DEVELOPMENT ASSESSMENT CASE NUMBER: CD-2014-0005.SH

Presentation of a Development Assessment Report for the Colony Park Sustainable Community Initiative Planned Unit Development (PUD), located at Loyola Lane and Wentworth Drive, within the Walnut Creek, Elm Creek and Decker Creek watersheds.

MASTER REVIEW REPORT

PROJECT NAME: Colony Park Sustainable Community Initiative PUD – DEVELOPMENT ASSESSMENT

DEVELOPMENT
ASSESSMENT
LAND PLAN

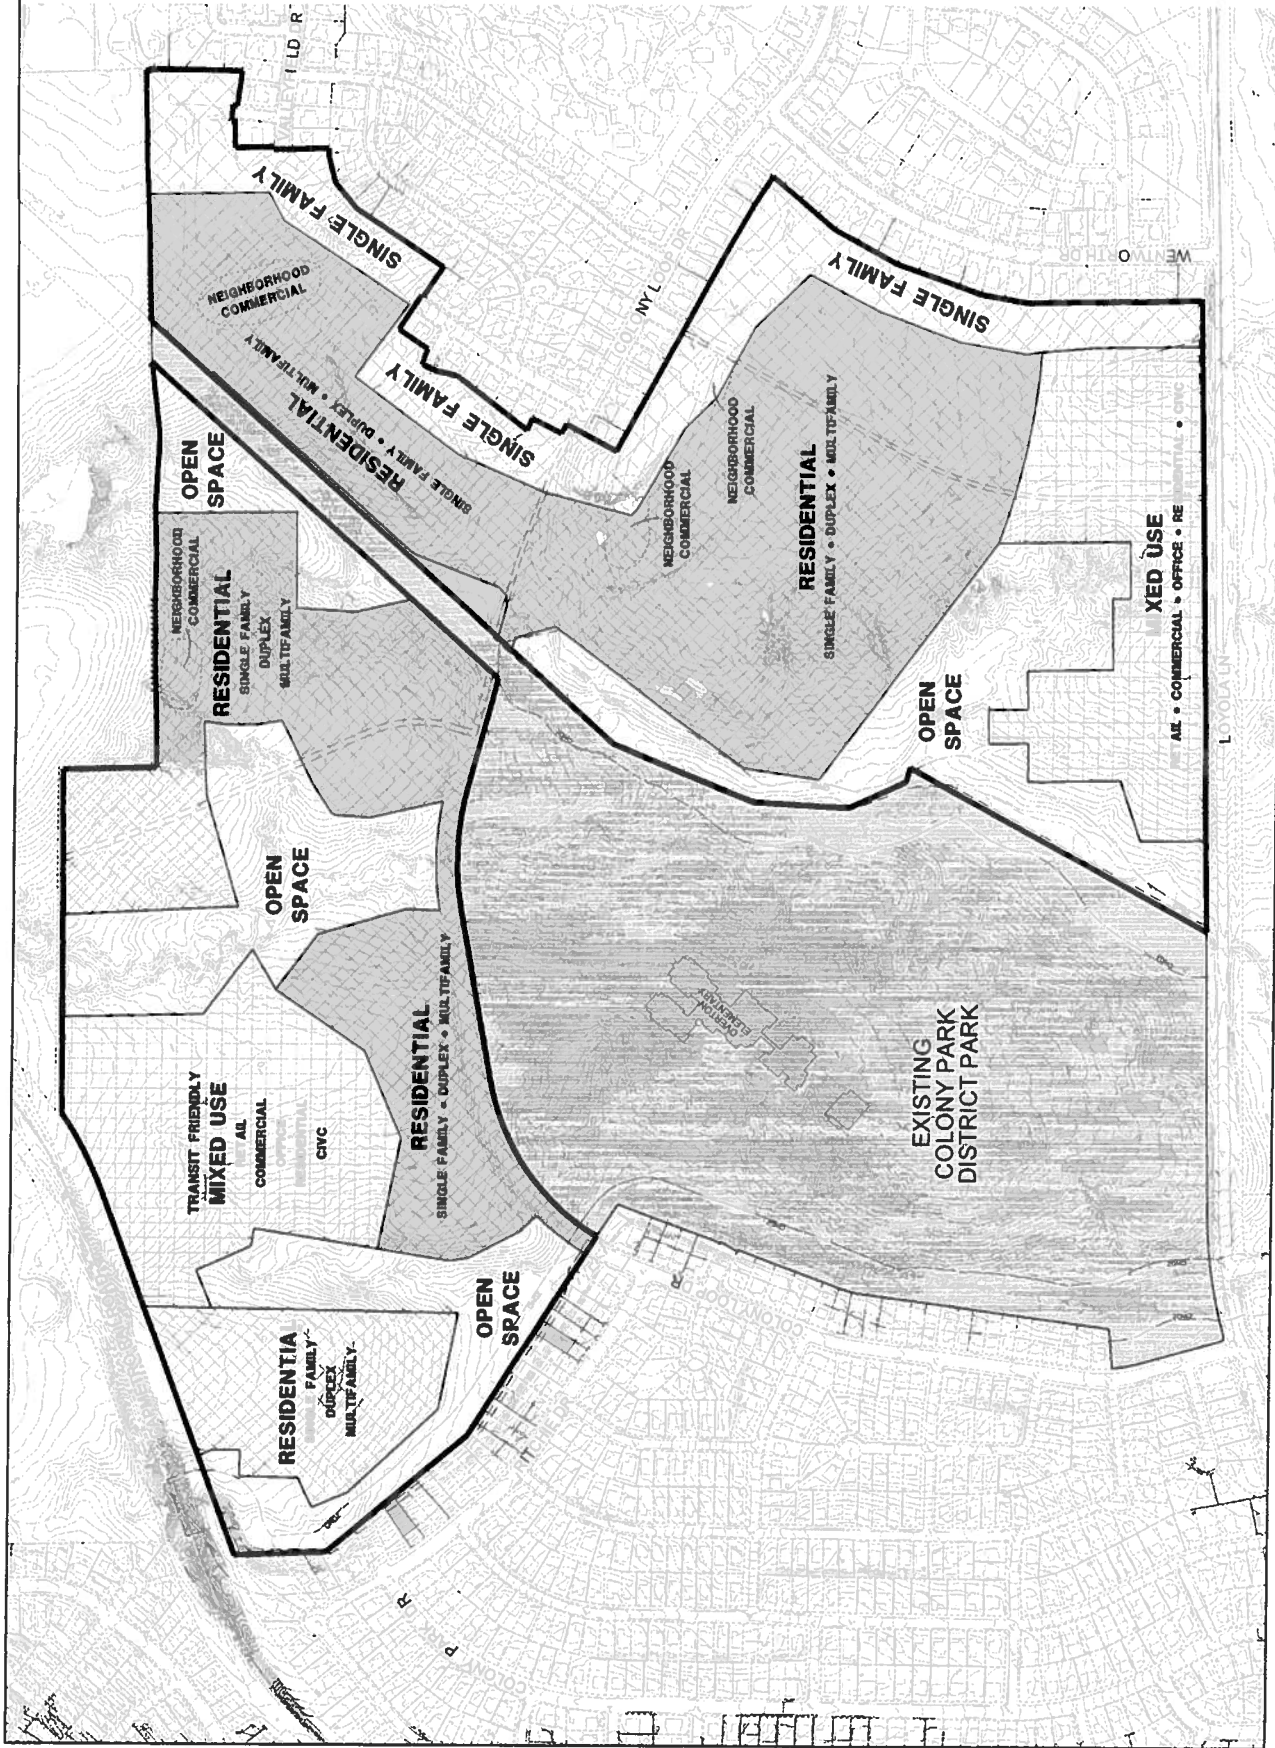
ZN 1. Add the following information to the Land Use Plan: existing land uses, existing zoning (onsite and adjacent). Zoning and land use should be shown for surrounding properties within 200 feet of project.

ZN 2. Show and label clearly the existing and proposed streets and/or roadways. For example, clearly label where existing Colony Loop Drive ends, and proposed extension begins, as well as right-of-way (ROW) widths. If street names have not yet been assigned, use something like "Street A, Street B," etc.

ZN 7. Add page numbering (1 of 1, etc.) to each sheet. Provide a site location map (minimum 5" x 5") that clearly shows the PUD project location in relation to city, major roadways. Recommendation: remove hatching from Land Use Areas so topographic information will be easier to read.

ZN 8. Clearly show and label all easements on the property, including recording information.

ZN 9. Specify the maximum number of curb cuts or driveways serving a non-residential project, which shall be the minimum necessary to provide adequate access to the site (Mixed Use Area adjacent to Loyola). Show all adjacent/nearby driveways/curb cuts on land use plan.

UDG RESPONSE: The existing and surrounding zoning and land uses of SF-2, SF-3, MF-2, and the surrounding zoning and land uses will be added to the PUD application.

UDG RESPONSE: Street names or designations and ROW widths will be added to PUD.

UDG RESPONSE: This will be done.

UDG RESPONSE: This will be done.

UDG RESPONSE: This will be addressed by the Master Plan documents and illustrative Plan.
